ESTERO CROSSING - OAK & STONE - PZDB MEETING

Estero, FL November 9, 2021

PIM COMMENTS

COMMENTS FROM JUNE 8, 2021 PIM MEETING

ARCHITECTURAL PLANS – NORTHEAST PERSPECTIVE

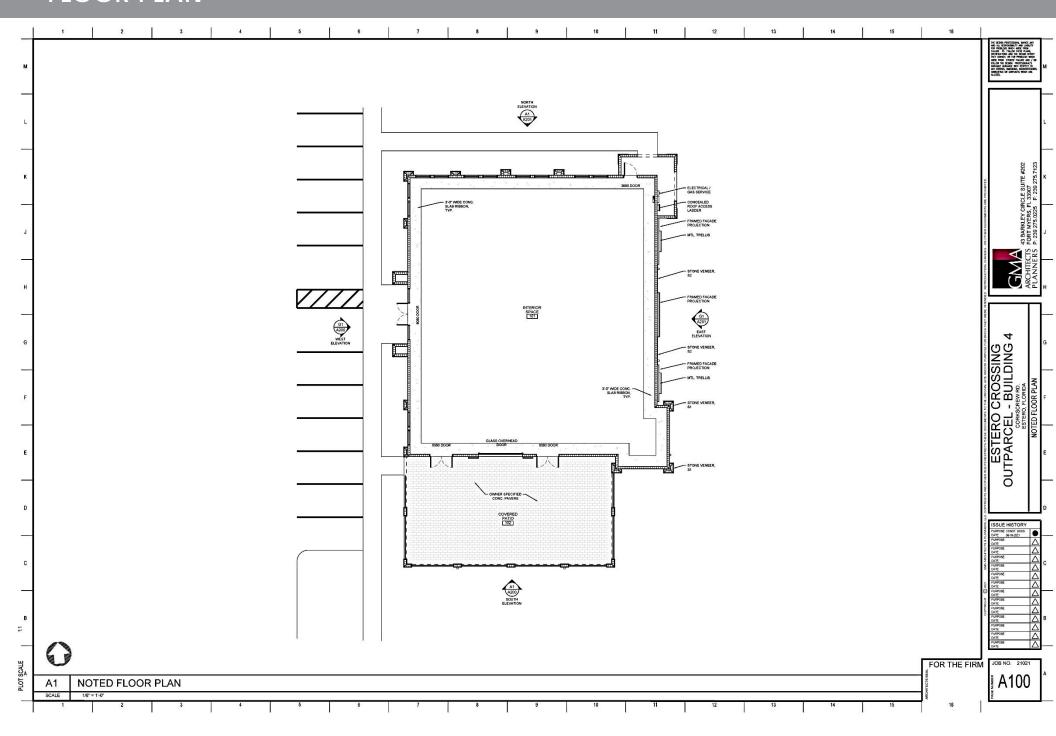
COMMENT: VISIBILITY OF SERVICE FUNCTIONS

COMMENT: VIEW OF BACK OF BUILDING (PRIMARY FAÇADE)

RESPONSE/REVISION: TOWER ADDED TO SHEILD SERVICE DOOR AT BUILDING; SCREEN WALL ADDED AT DUMPSTER ENCLOSURE TO SHEILD ENTRY.

RESPONSE/REVISION: REAR FAÇADE ENHANCED WITH ARCHITECTURAL ELEMENTS, TOWER ADDED AT CORNER TO SHIELD SERVICE DOOR, ADDITIONAL TREES ADDED BEHIND BUILDING.

WALL SIGNAGE

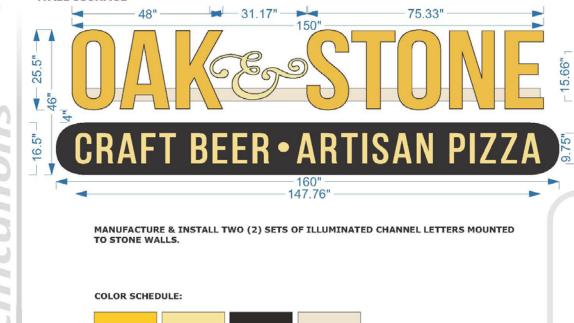
COMMENT: BUILDING SIGNAGE

RESPONSE/REVISION: PROPOSED WALL SIGNAGE INCLUDED ON BUILDING ELEVATIONS; SIGN DETAIL PROVIDED.
